RESUBDIVISION OF LHRP COMMERCIAL PARK **SUBDIVISION**

APPLICATION NUMBER 11 DATE May 17, 2018
APPLICANT LHRP Commercial Park Subdivision, Resubdivision of
REQUEST Subdivision

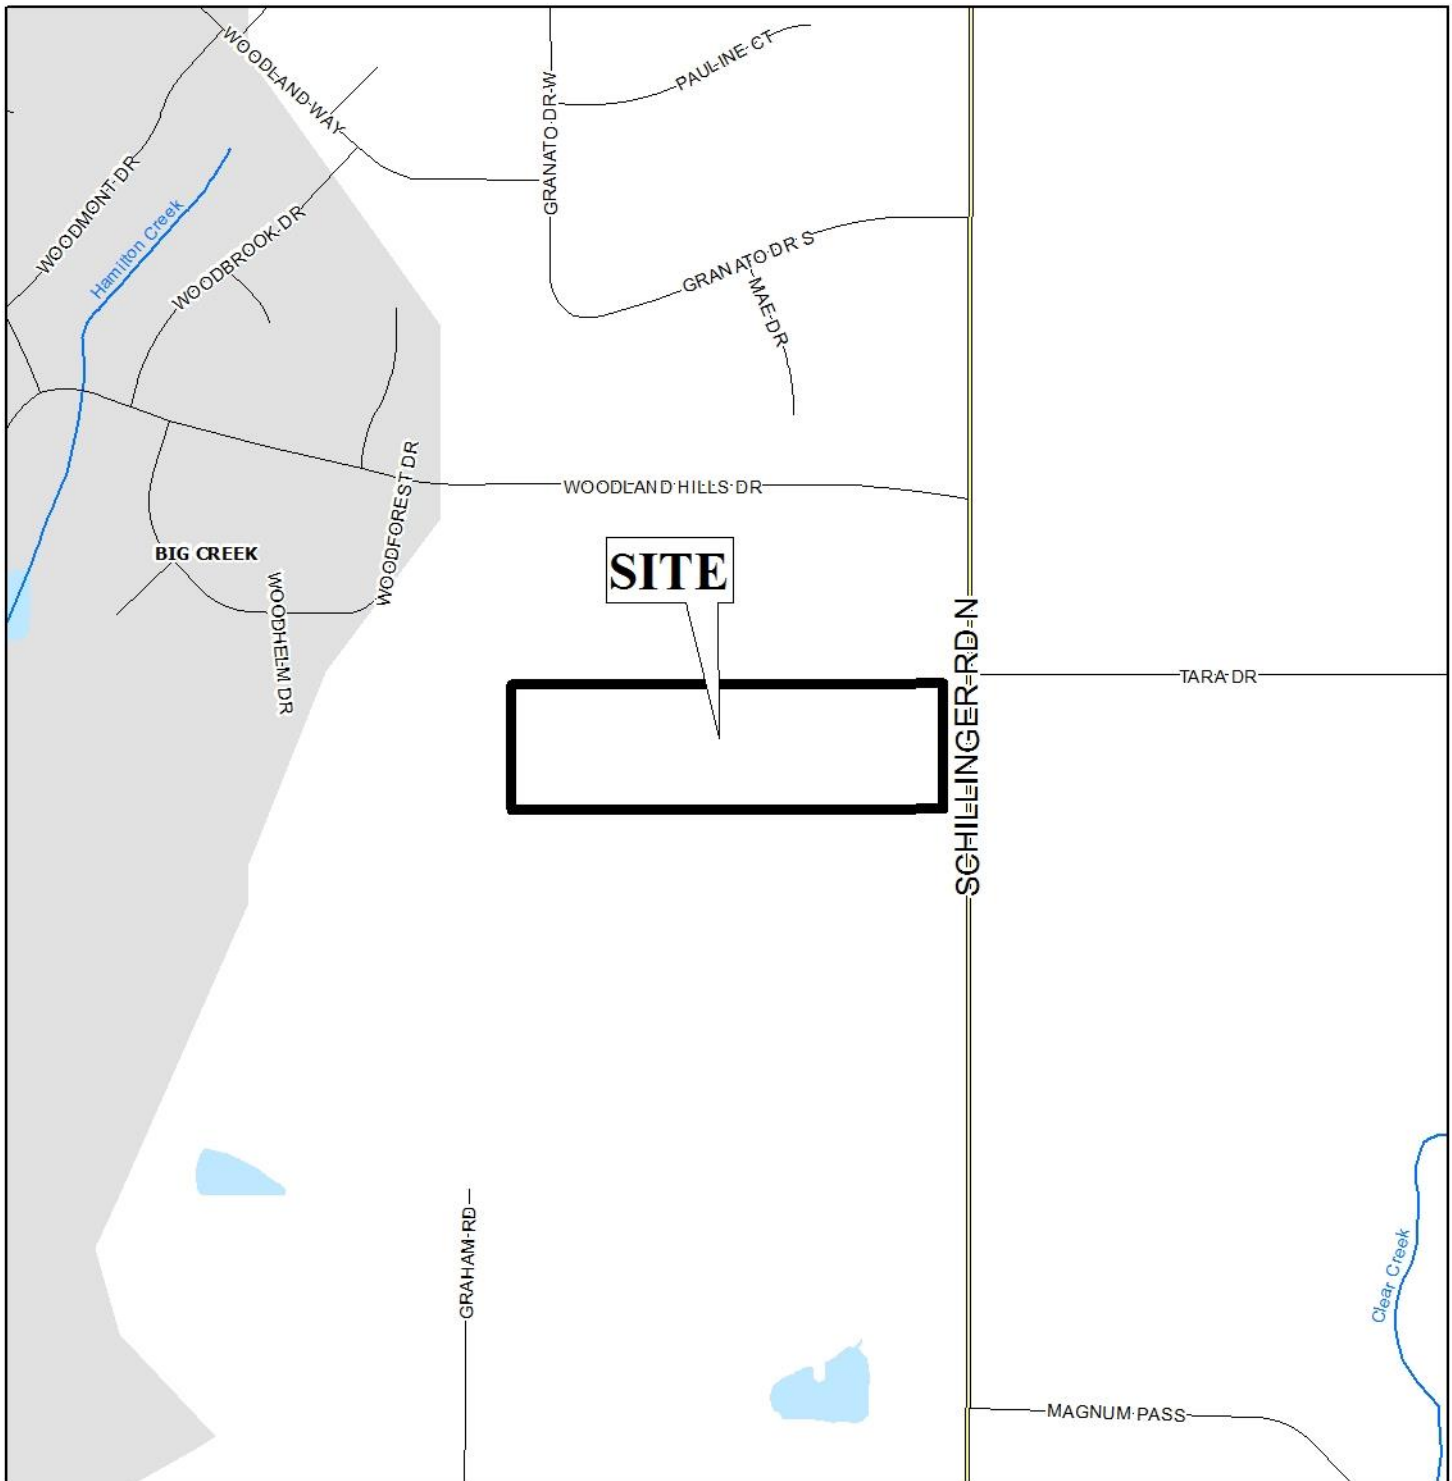
The proposed lots have frontage on Schillinger Road North, a major street with curb and gutter requiring a 100' right-of-way width. The plat depicts a previous acquisition of right-of-way along the site's frontage to provide 70' from the centerline of Schillinger Road North, thus no dedication should be required.

Proposed Lot 3 is a flag lot with a 28'-wide pole. The Planning Commission has approved various iterations of the LHRP Commercial Park Subdivision that also included flag lots; therefore, approving the request may be appropriate with a waiver of Section V.D.1. of the Subdivision Regulations.

The lots each meet the minimum size requirements for lots served by public water and sanitary sewer systems and are appropriately labeled with their sizes in square feet and acres on the preliminary plat. This information should be retained on the Final Plat, if approved; or, provision of a table providing the same information may suffice.

A 50' minimum building setback line is illustrated along Schillinger Road North, though 25' is the minimum should the applicant choose to revise the plat to reduce the building setback line. It should be noted that, while a building setback is indicated along the frontage of the proposed Lot 3, revision of the plat should be required to illustrate the 25' minimum building setback where Lot 3 is at least 60' in width. Nevertheless, the minimum building setback line should be retained on the Final Plat, if approved, adjusted for Lot 3.

Regarding access management, Lots 1 and 3 would share access to Schillinger Road North via a proposed ingress/egress/parking easement. Lot 2 will not share access with Lots 1 and 3. As such, a note should be placed on the Final Plat stating that Lots 1 and 3 are limited to one (1) shared curb cut to Schillinger Road North, and Lot 2 is limited to one (1) curb cut to Schillinger Road North, with any changes in their sizes, locations or designs to be approved by Mobile County Engineering and conform to AASHTO standards.

As mentioned, the vacation of eight (8) easements was approved by the Planning Commission at its April 19th meeting, but a 20' X 440'± drainage and utility easement remains along the South property lines of all three (3) lots, along with the aforementioned ingress/egress/parking easement. A note on the plat states no structures are to be constructed in any easement, which should be retained on the Final Plat, if approved.

It should also be noted that easement deeds were recorded in Mobile County Probate Court on August 25, 2014 and May 18, 2015 by the property owner granting Alabama Power an easement to the entirety of Lots 1, 2, and 3 of the previously recorded LHRP Commercial Park Subdivision. The easement deeds grant Alabama Power authority to establish an easement anywhere, and at any time deemed necessary and appropriate on the subject site. Alabama Power does not yet appear to have made use of this provision since no Alabama Power easement is illustrated or mentioned on the submitted drawing; however, revision of the plat to provide a note acknowledging the Alabama Power easement deeds should be required, if approved.

With a waiver of Section V.D.1. the proposed plat meets the minimum requirements of the Subdivision Regulations and is recommended for Tentative Approval, subject to the following conditions:

- 1) retention of the lot sizes in square feet and acres on the Final Plat, or provision of a table providing the same information;
- 2) retention of at least a 25' minimum building setback line along Schillinger Road North for Lots 1 and 2;

- 3) revision of the plat to illustrate the 25' minimum building setback line where Lot 3 is at least 60' in width;
- 4) placement of a note on the Final Plat stating that Lots 1 and 3 are limited to one (1) shared curb cut to Schillinger Road North, and Lot 2 is limited to one (1) curb cut to Schillinger Road North, with any changes in their sizes, locations or designs to be approved by Traffic Engineering and conform to AASHTO standards;

- 5) retention of a note on the Final Plat stating no structures shall be constructed in any easement;
- 6) revision of the plat to provide a note acknowledging the Alabama Power easement deeds;
